RE: Request for Advice – Response to Submissions – Discovery Point Concept Plan – Modification 5 (MP10_0003 MOD 5)

Thank you for the opportunity to provide comment on the Response to Submissions (RtS) for amendments to Modification 5 of the Part 3A Discovery Point Concept Plan, relating to Building 14 at Discovery Point, Wolli Creek (the site).

Figure 1: Building Separation, Source: Appendix D – Amended Concept Plan Drawing, Bates Smart (2024)

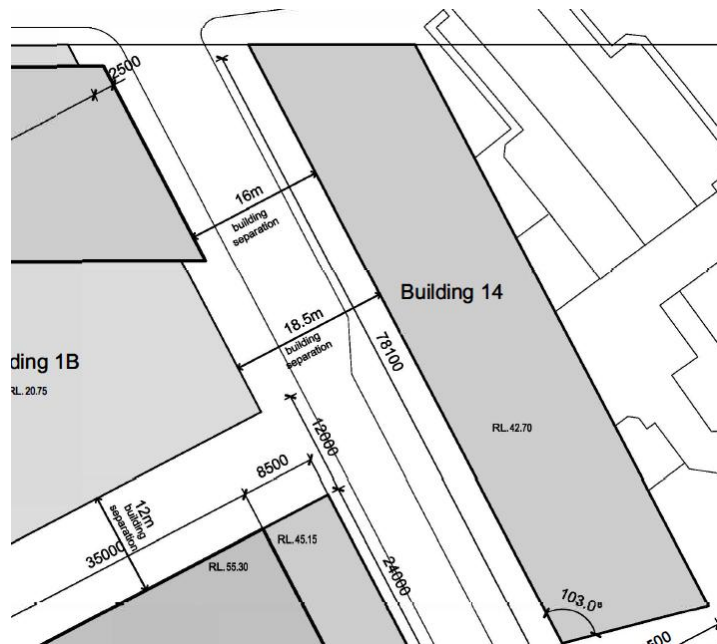
Building Separation

Under Section 69 (2) (b) of Housing SEPP 2021 the proposal does not meet the minimum building separation requirement of 18 metres for buildings between 5 and 8 storeys, as specified for the distance between habitable rooms and balconies at both Building 1B (6 Discovery Point) and Building 1C (5 Brodie Spark Drive). Any modification to the building layout for Building 14 will need to demonstrate compliance with the separation distances required under the Housing SEPP 2021.
